**STAFF MEMO**

**Date:** February 8, 2021  
**To:** Town of Milford Planning Board  
**From:** Jason Cleghorn, Town Planner  
**Subject:** **SP2021-04 Crosby Townhomes, Kling/Mengyuan Property Management, 159 Elm Street, Map 19, Lot 5.** Public Hearing for a major site plan application to construct a six (6) unit townhouse, multi-family residential project with related parking, drainage/stormwater management, landscaping, and lighting improvements.

Proposed Elevation from Elm St. looking north

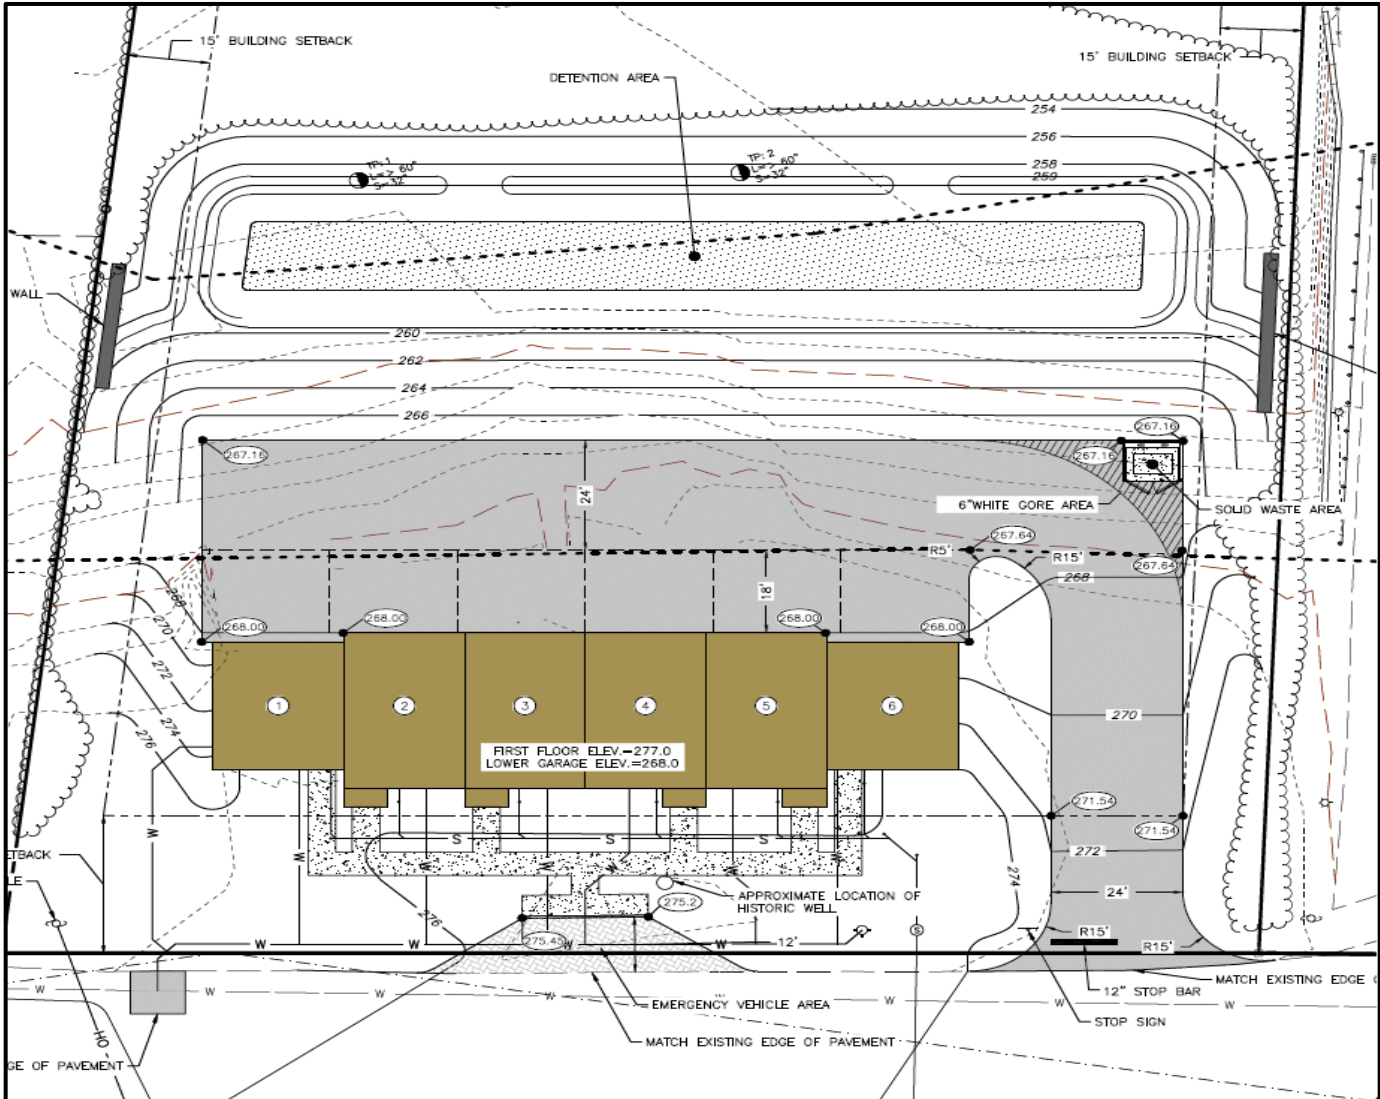
6. Elevations: Per § 6.04.2 of the Development Regulations, plans shall show all building elevations. The submitted elevation is only 1 view of 4. Please include the other three elevation views. While the parking is located in the rear of the building, the Town would still like to see these additional elevations. Staff may have additional comments pending the receipt of these elevations.

**SP-2**  
SHEET  
FILE: 10839100.dwg  
PROJECT: 10839.00  
SHEET NO. 4 OF 12

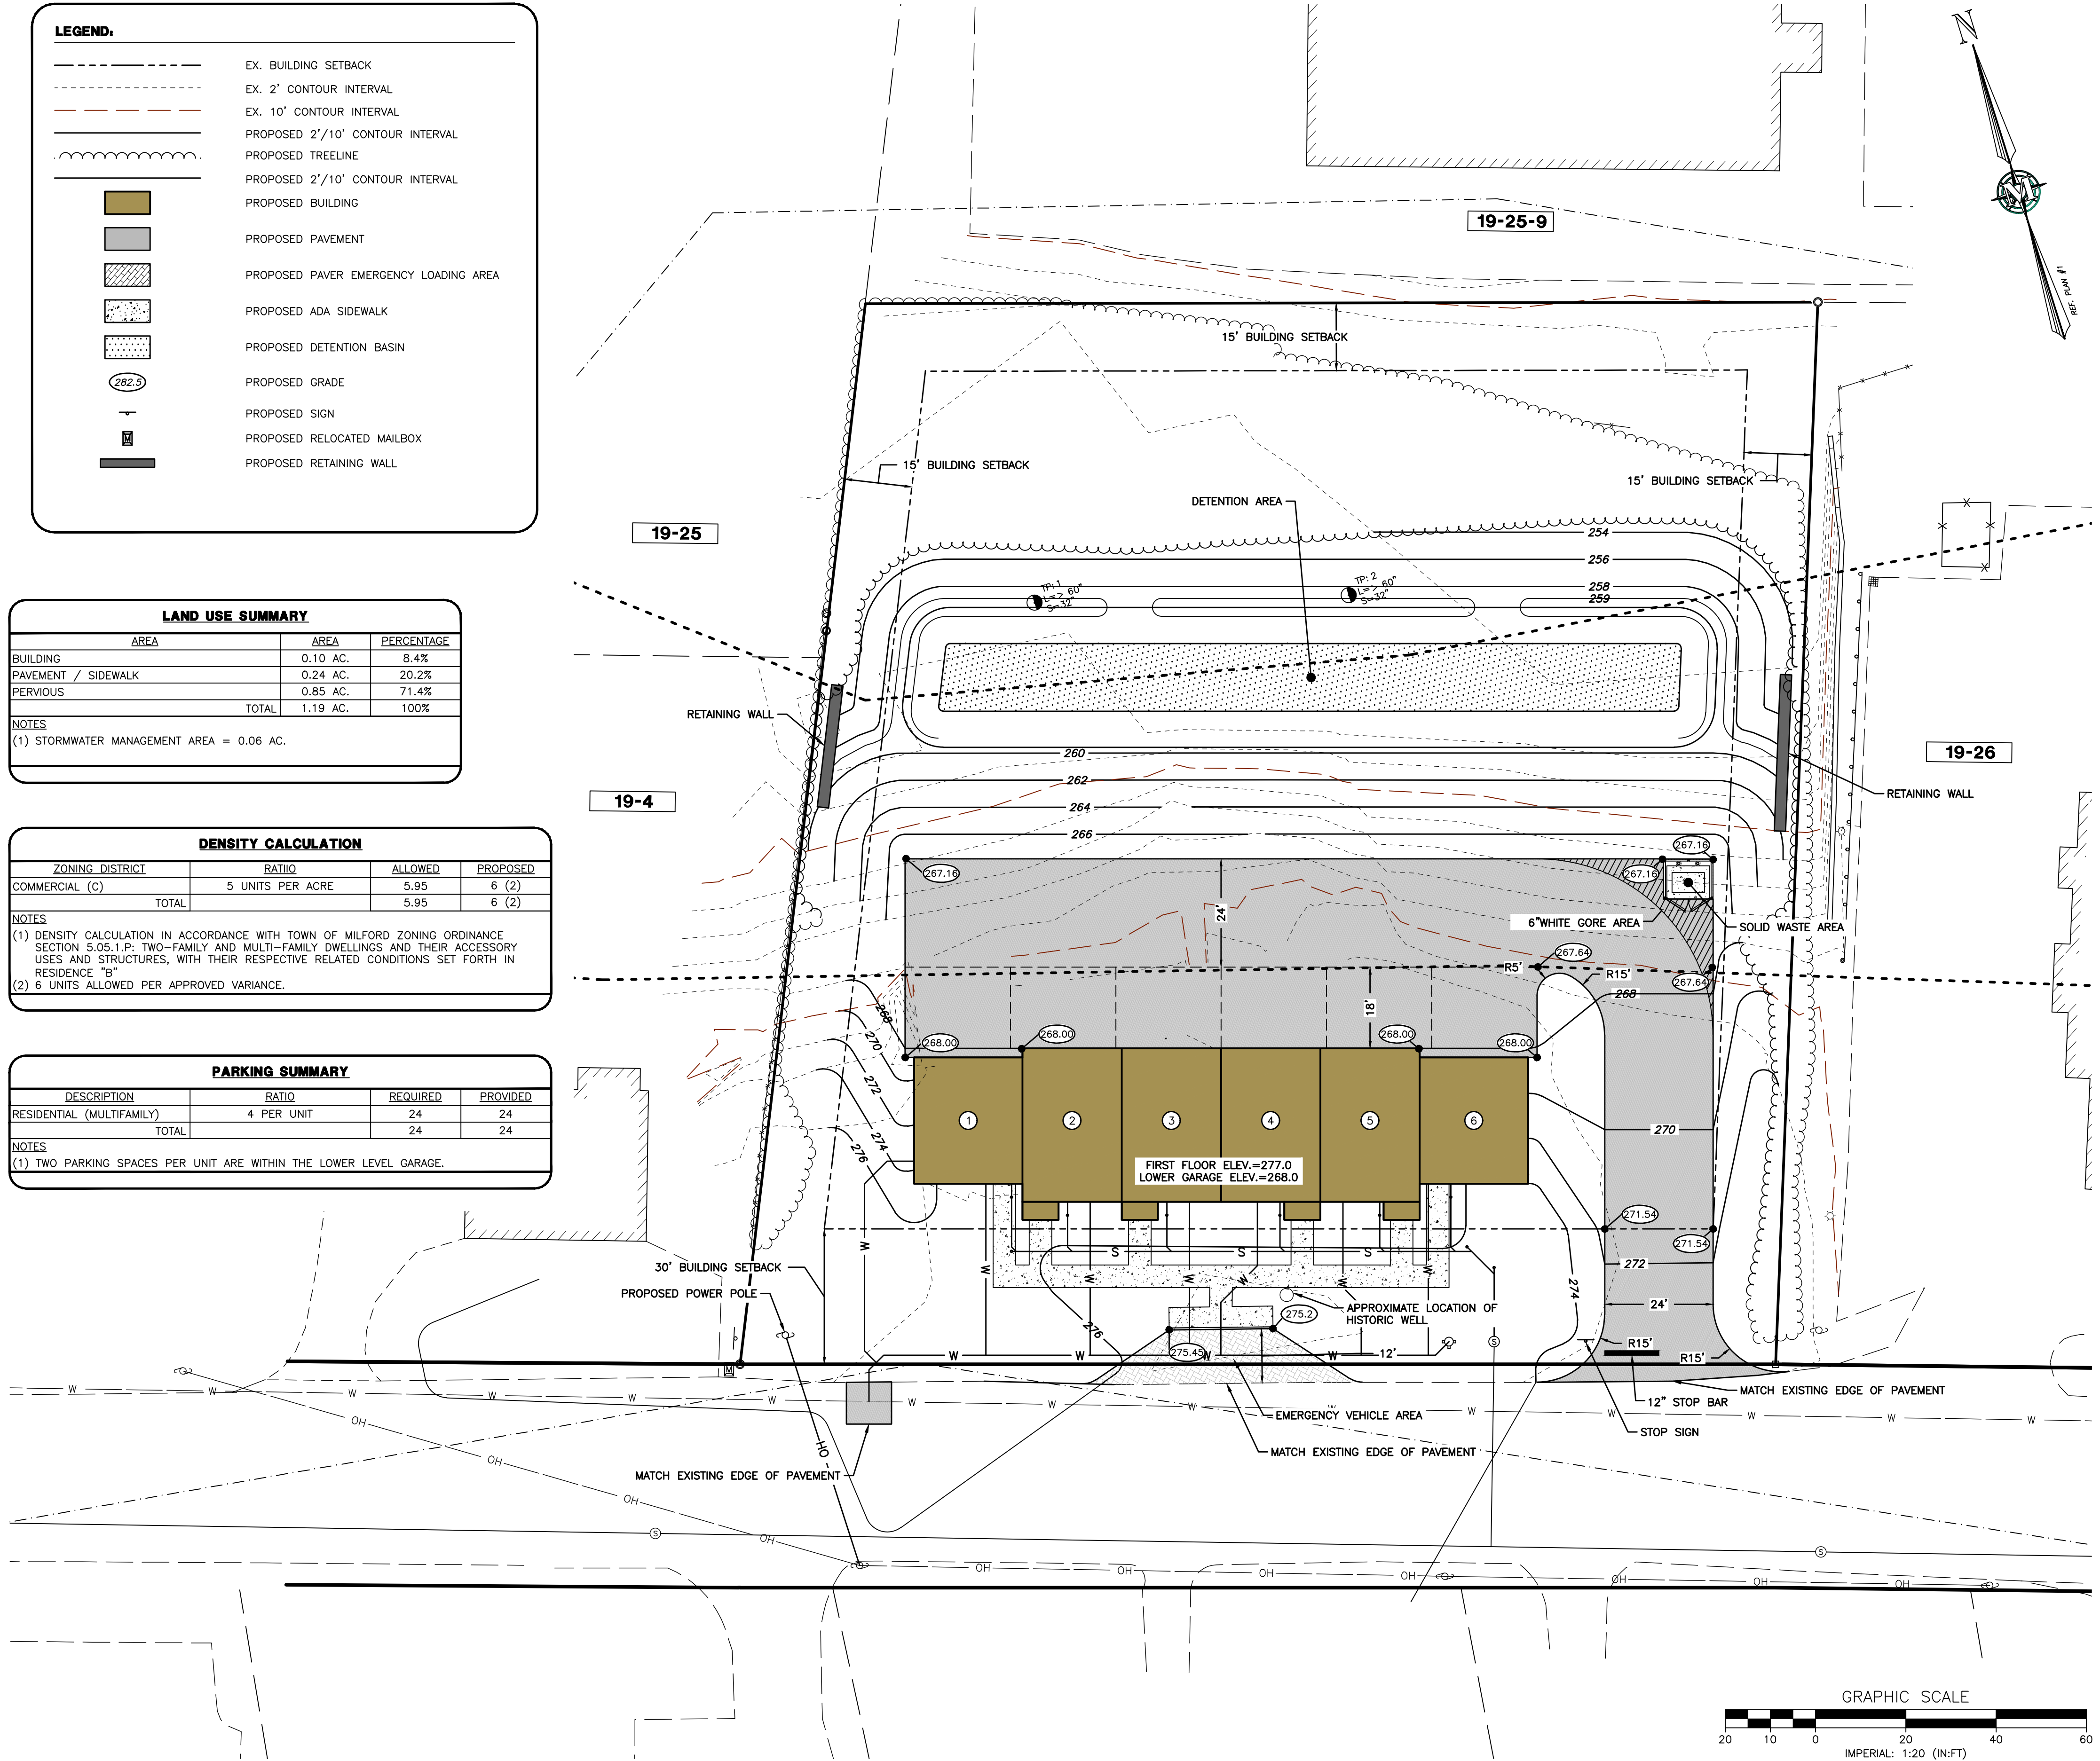
1. Sheet SP-2: Please revise the plan to include the location, size, and details of any signage related to the townhomes.
2. Sheet SP-2: Please revise the plan to include the location, size, and details of any exterior lighting. Per Town of

Milford Development Regulations § 6.06, all outdoor lighting shall be downcast and directed such that no glare spills onto adjacent properties or roads. Consider adding a standard detail depicting the type of lighting to be utilized.

3. Sheet SP-2: Revise the land use summary to be more implicit regarding the amount of Open Space on the site. The current table just uses the term pervious and this table could be clearer.

4. Sheet SP-2: Add a note to the plan about the existence of Impact Fees related to the project. (§5.04 BB Town of Milford Development Regulations)
5. Sheet SP-2: Striping should be shown for the two (2) parking spaces per unit that are not contained within the garage in order for Staff to better evaluate vehicular movement flow through the rear of the site and for determination whether the corresponding drive aisle can be kept clear. Guidance can be found in § 6.05 of the Town's Development Regulations regarding the minimum size for parking spaces and their layout.
